# Access Compliance Report

## Public Rights-of-Way

### (Curb Ramps)

Intersection ID: 10023986	Main Street: COPPER_WY	Cross Street: N/A	Location: W
ADA ID: 5D821593179F	Ramp Type: Perp	Initial Pass/Fail: Fail	Overall Compliance: No
		Severity Score: 25

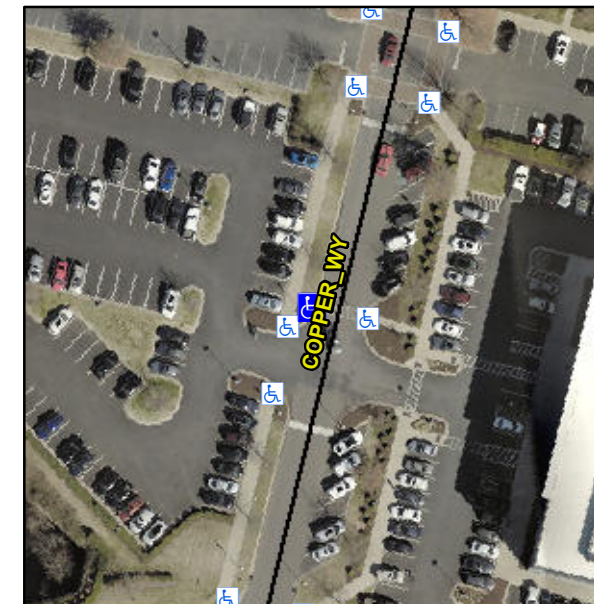
Compliance	Description	Data	Compliance	Description	Data
N/A	Ramp Length (in)	99.0	No	Ramp Slope (%)	14.0
Yes	Ramp Width (in)	48.0	Yes	Ramp XSlope (%)	1.7
N/A	Flare Type LT	N/A	N/A	Flare Type RT	N/A
N/A	Flare Slope LT (%)	N/A	N/A	Flare Slope RT (%)	N/A
N/A	Flare Traversable LT?	N/A	N/A	Flare Traversable RT?	N/A
N/A	Landing Length (in)	N/A	N/A	DWS Provided?	N/A
N/A	Landing Width (in)	N/A	N/A	DWS Contrast?	N/A
N/A	Landing Slope (%)	N/A	N/A	DWS Length (in)	N/A
N/A	Landing X Slope (%)	N/A	N/A	DWS Full Width?	N/A
N/A	Landing Curb? (Y/N)	N/A	N/A	DWS Offset (in)	N/A
N/A	Shared Landing?	N/A			
N/A	Gutter Ponding?	N/A	N/A	Gutter Slope (%)	N/A
N/A	Gutter Lip Ht (in)	N/A	N/A	Gutter X Slope (%)	N/A
N/A	Painted X Walk1?	Yes	N/A	Painted X Walk2?	N/A
	X Walk 1 Direction	To E		X Walk 2 Direction	N/A
N/A	X Walk 1 Width (in)	55.5	N/A	X Walk 2 Width (in)	N/A
	X Walk 1 Slope (%)	1.2		X Walk 2 Slope (%)	N/A
	X Walk 1 X Slope (%)	0.2		X Walk 2 X Slope (%)	N/A

**Remove & Replace Entire Ramp.**

**R304.2.2**
